RE: Bluewater Mill Site Reclamation Completion Report Comments
License No. SUA-1470, Docket No. 40-8902

Response to NRC's Comments

ADDENDUM 1
RESPONSE TO NRC COMMENTS

FIGURE 3-2
Ra-226 CONCENTRATION
FOR SURFACE LAYER

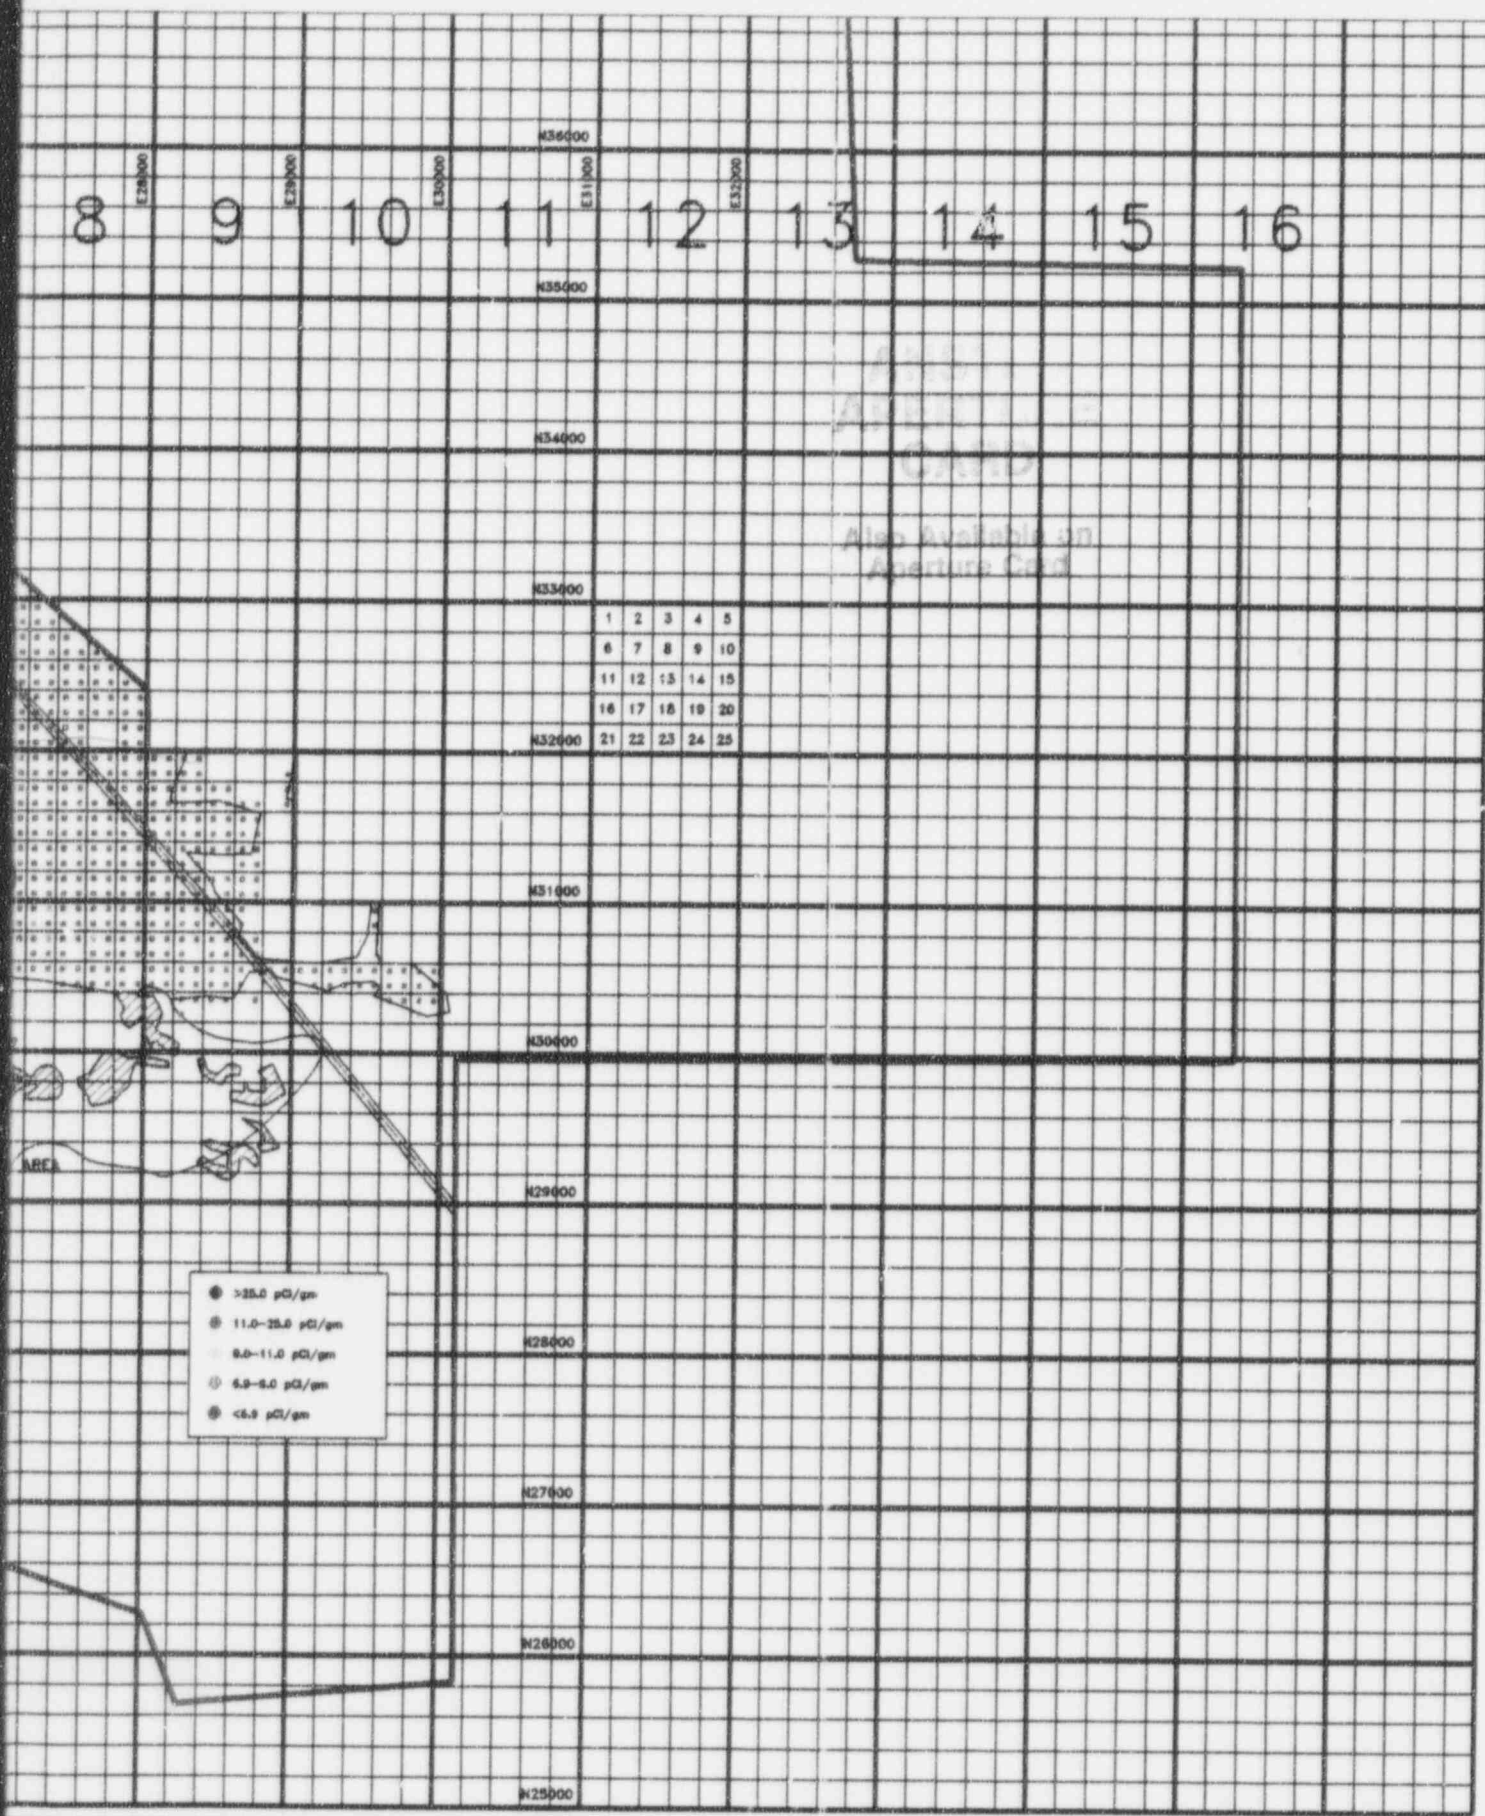
Several Figures in Section 6 indicate an exemption boundary, but the bounded area seems to include much more than the Malpais exemption area (see Drawing 1 in the 1992 Cleanup Report). ARCO should clarify why the areas between the disposal cells and west of the Main Tailings Cell are included within the exemption boundary, and perhaps provide the map from the 1994 exemption request.

As discussed in the response to Comment No.1, Drawing 1 in 1992 Windblown Cleanup Report shows only the 210 acre Malpais Exclusion, which ARCO requested in the November 17, 1987 request for Modification of the Reclamation Plan. The Exemption Boundary in Figure 3-1, 3-2 and B-1 (Appendix B) of the 1994 Exemption Request, includes the Malpais Exclusion as well as other areas within the Site, including the areas between the disposal cells and west of the MTP.

The areas between the disposal cells and west of the MTP are also malpais outcrops where sampling and cleanup was impractical. Therefore, the areas between the disposal cells and west

of the MTP were included within the Exemption Boundary. The January 1994 Exemption Request was approved by the NRC by License Amendment No. 23. Figures in Section 6 of the CR have the same Exemption Boundary as Figures 3-1, 3-2, and B-1 of the Exemption Request. Copy of Figure 3-2 of the 1994 Exemption Request is included in Attachment 3.
